Latest Firmware for the mObridge DA2 Preamp

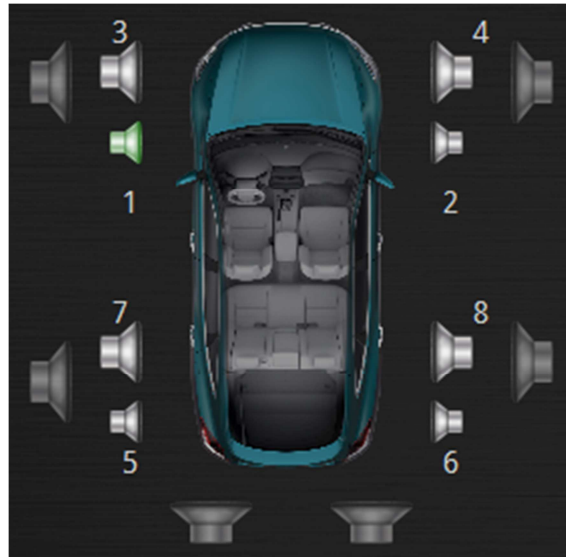
Pls note: When upgrading to the new software from versions 1.7.0 and up that now have channel mapping, the DA2 if previously fitted may possibly have the channels now mapped differently from what the user may currently have setup. The default mapping can be seen in the below figure:

All channels have a flat response curve.
